Part Name: Skidtube with Standard Wearplates Fits LH or RH

DART SERVICE INSTRUCTION

TO AMEND INSTALLATION INSTRUCTIONS IIN-D117-762 REV. E AND INSTRUCTIONS FOR CONTINUED AIRWORTHINESS ICA-D117-762 REV. 4

A	NEW ISSUE	RF	17.01.09
REV.	DESCRIPTION	BY	DATE
DESIGN	RF	DART AEROSPACE, LTD EUGENE, OR	
DRAWN	RF		
CHECKED	WK	DRAWING NO.	REV.A
MFG. APPR.	N/A	DSI 9771	SHEET 1 OF 2
APPROVED	HS	TITLE	SCALE
DE APPR.		GHL UPGRADE KIT	NTS
DATE	17.01.09	COPYRIGHT ©2017 BY DART AEROSPACE USA, INC THIS DOCUMENT IS PRIVATE AND CONFIDENTIAL AND IS SUPPLIED ON THE EXPRESS CONDITION THAT IT IS NOT TO BE USED FOR ANY PURPOSE OR COPIED OR COMMUNICATED TO ANY OTHER PERSON WITHOUT WRITTEN PERMISSION FROM DART AEROSPACE, LTD.

FIGURE 1 - GH L UPGRADE INSTALLATION

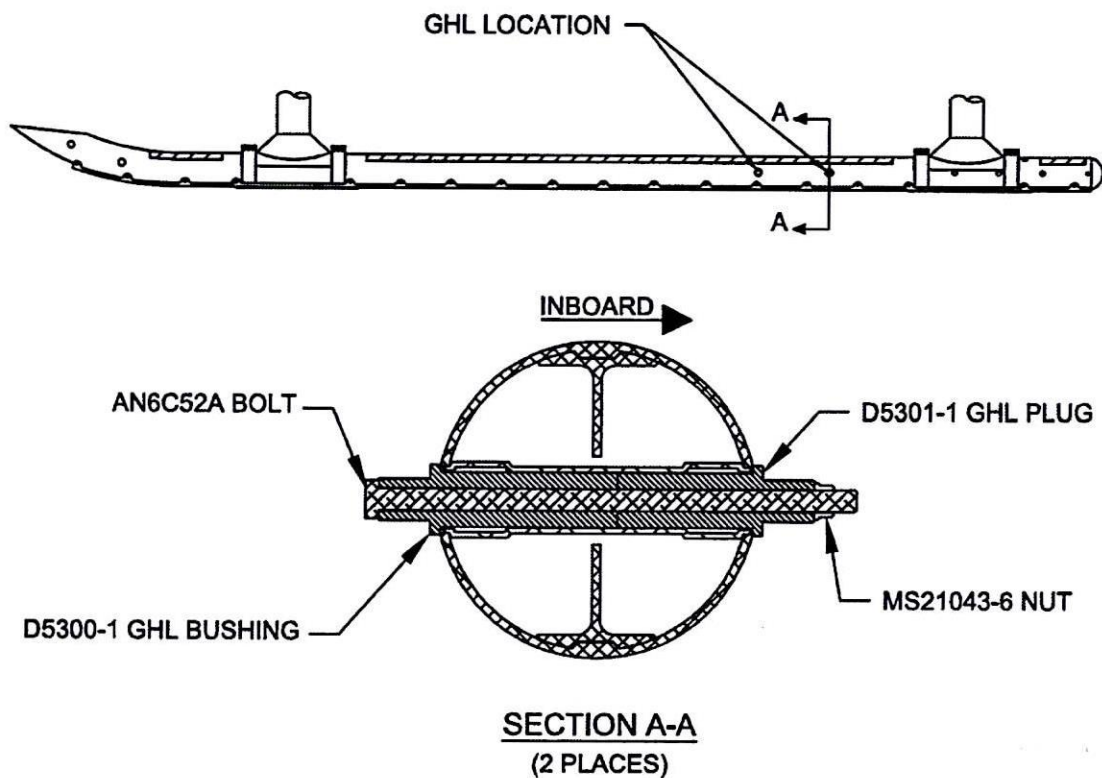
The purpose of this Dart Service Instruction (DSI) is to replace the ground handling lugs (D3864-1 Bushings, AN6C51A Bolts and MS21043-6 Nuts) on the D117-762-XXX Skid tubes with a structurally superior lug design (D5300-1 Bushings, D5301-1 Plugs, AN6C52A Bolts, MS21043-6 Nuts) as shown in Figure 1. The new hardware will be included in D117-762-011 @ CHG 004 and subsequent.

- 2.1 Loosely install (qty 2) D5300-1 GHL Bushing & (qty 2) D5301-1 GHL Plug wet with Proseal 890 or MIL-S-8802 Class B2 Sealant in location shown in Figure 1.
- 2.2 Install (qty 2) AN6C52A Bolts and (qty 2) MS21043-6 Nuts in accordance with Figure 1. Clean up squeezed out Proseal and apply fillet seal around D5300-1 & D5301-1.
- 2.3 Torque AN6C52A Bolts 160 - 190 in-lbs (18.1 - 21.5 N-m).

ITEM	QTY -011	PART NUMBER	DESCRIPTION
	X	D117-762-011	SKIDTUBE INSTALLATION
50	2	AN6C52A	BOLT
51A	2	D5300-1	GHL BUSHING
51B	2	D5301-1	GHL PLUG
52	2	MS21043-6	NUT

ITEM	QTY -011	PART NUMBER	DESCRIPTION
	X	D117-762-011	SKIDTUBE INSTALLATION
50	2	AN6C51A	BOLT
51	4	D3864-1	BUSHING
52	2	MS21043-6	NUT
